Subject: FW: 23/02254/FUL The Rancher Manor Farm

Reference:	23/02254/FUL
Address:	The Rancher Manor Farm Lane Tidmarsh Reading RG8 8EX
Proposal:	Demolition of The Rancher and the construction of 2no detached dwellings.
Case Officer:	Awaiting Case Officer

Title:
**Swept Path Analysis
Site 1 Parking**

2211060-TK06

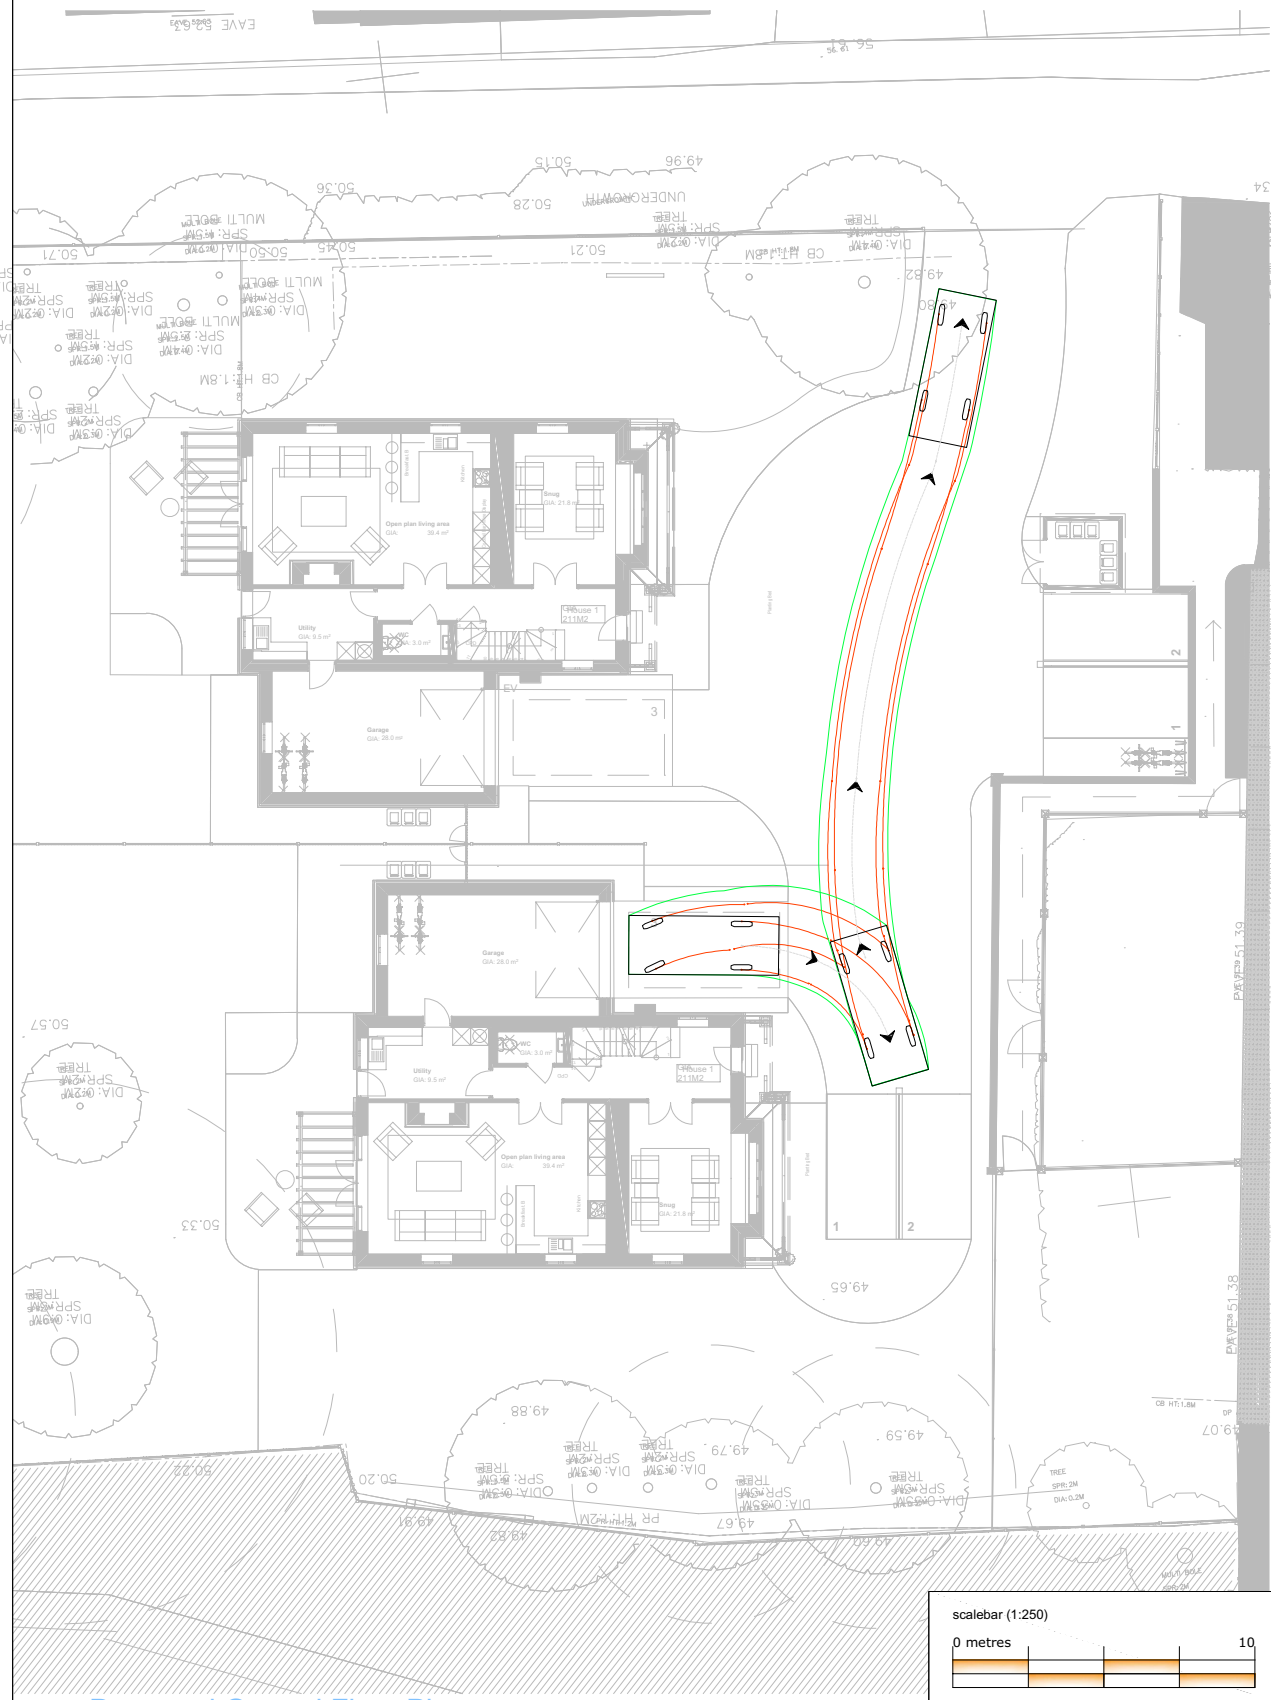
Plans detailing vehicle swept paths for the proposed car parking spaces have now been submitted. This is acceptable.
